Landscape Referral Response

Application Number:	DA2019/1141
Date:	20/11/2019
Responsible Officer:	Rhiannon McLardy
Land to be developed (Address):	Lot 39 DP 244404 , 41 Sir Thomas Mitchell Drive DAVIDSON NSW 2085

Fig. 1. Survey plan - Existing trees adjacent to proposed works

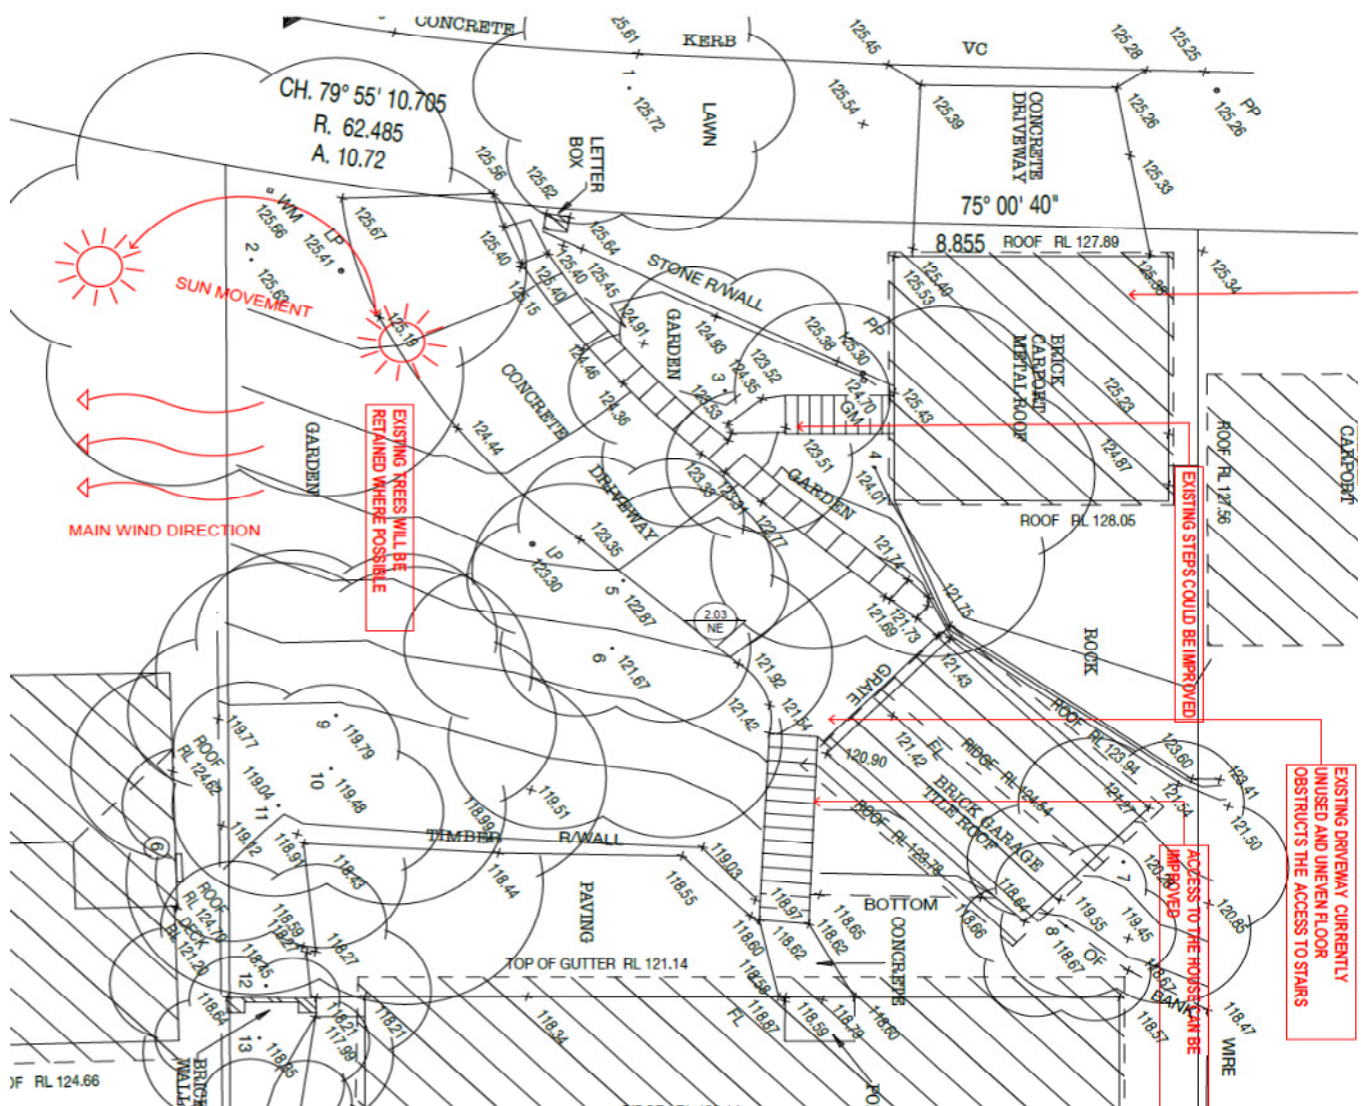
The plans indicate construction works in the front of the property. The SEE indicates that no trees are required to be removed, however comparison between the Survey Plan and the Street Level Plan (extracts below) indicates that a number of large trees will be required to be removed to accommodate the works. The Street Level Plan does not identify existing or proposed trees or trees to be removed. The Area Calculations Plan also appears to indicate terrace walls on the western side of the site.

Trees proposed to be removed are now indicated on the plans and it is noted that exempt trees under WDCP are to be removed, with others retained.

Fig 2. Street Level Plan extract. Trees to be retained/removed/new landscaping?

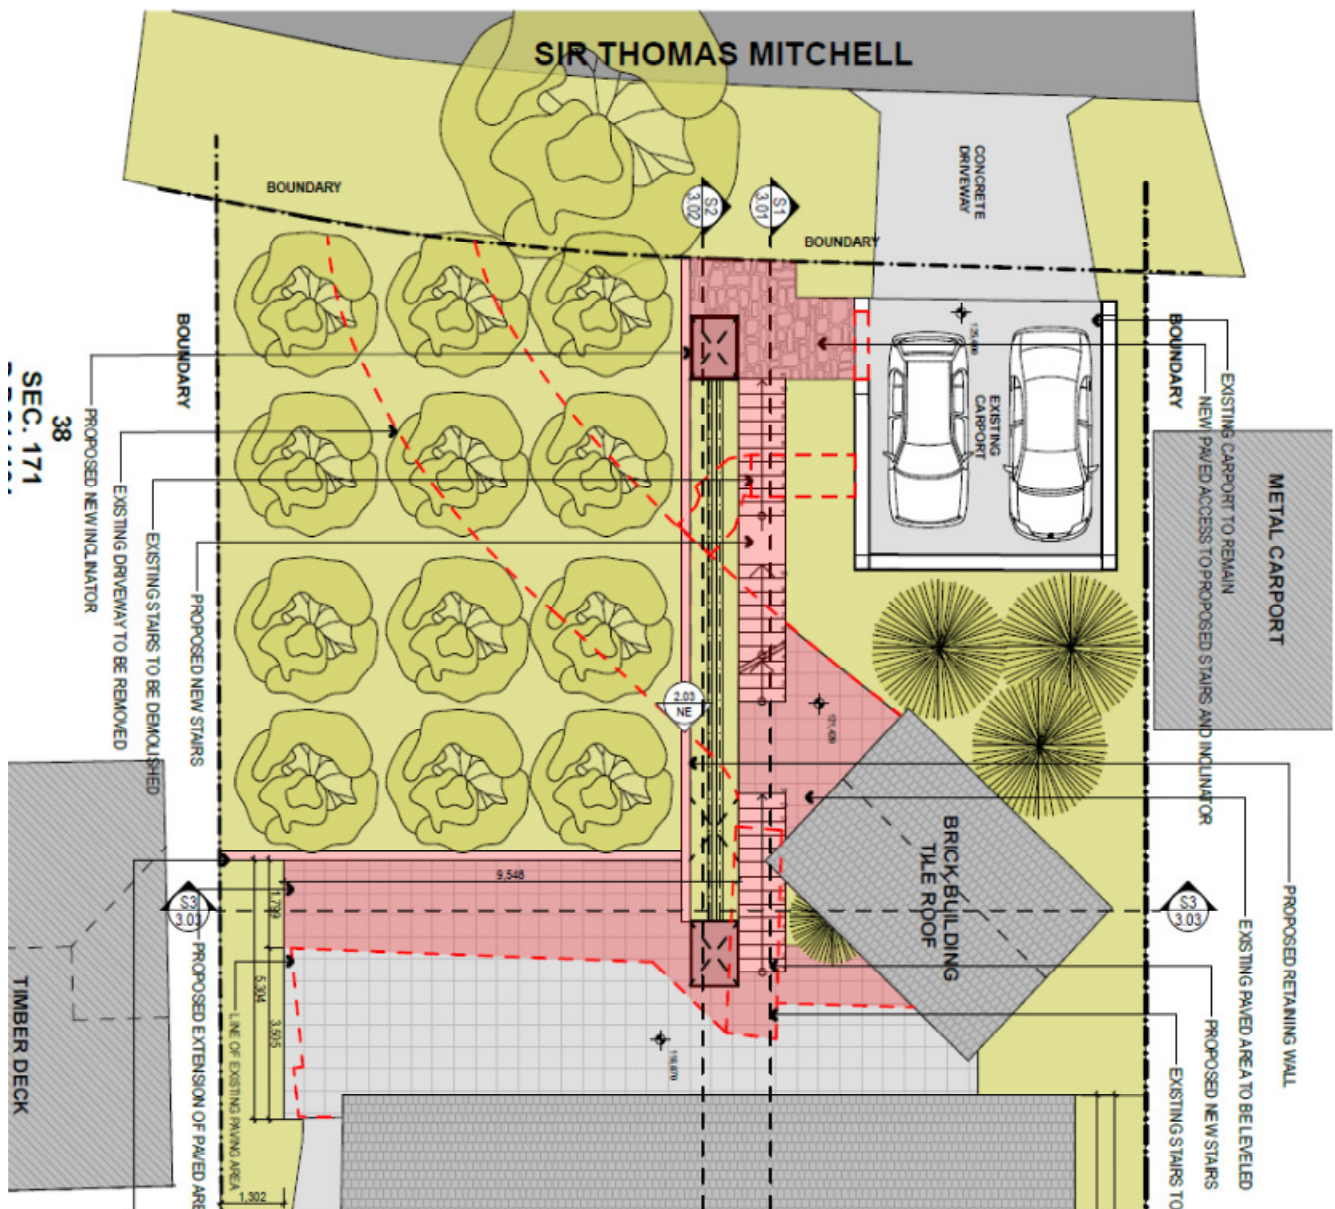
Additional information is required to identify trees to be removed and retained and proposed landscape works in the front of the site.
